# *The Heath & Hampstead Society*

**Planning Ref:** 2023/4898/P

**Address:** 2 and a half, Rudall Crescent London NW3 1RS

**Date:** 11<sup>th</sup> July 2024

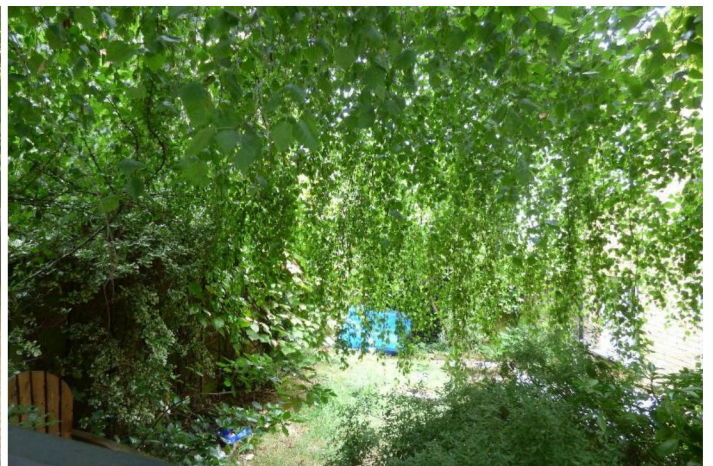
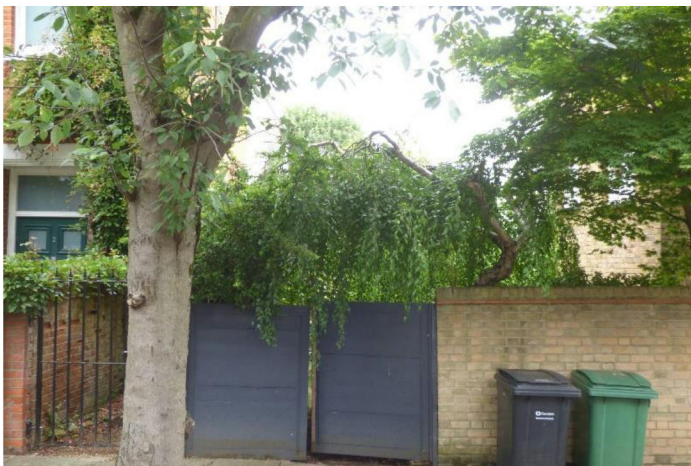
It is clear from the new entrance gate through the front boundary that the existing trees here will have to be removed to allow sufficient head height for access:

The low head room and low top branches of this beautiful weeping birch tree and its neighbouring maple tree – currently providing a large street treescape amenity – mean they will have to be felled. This will produce a huge loss in biodiversity, habitat and treescape amenity.
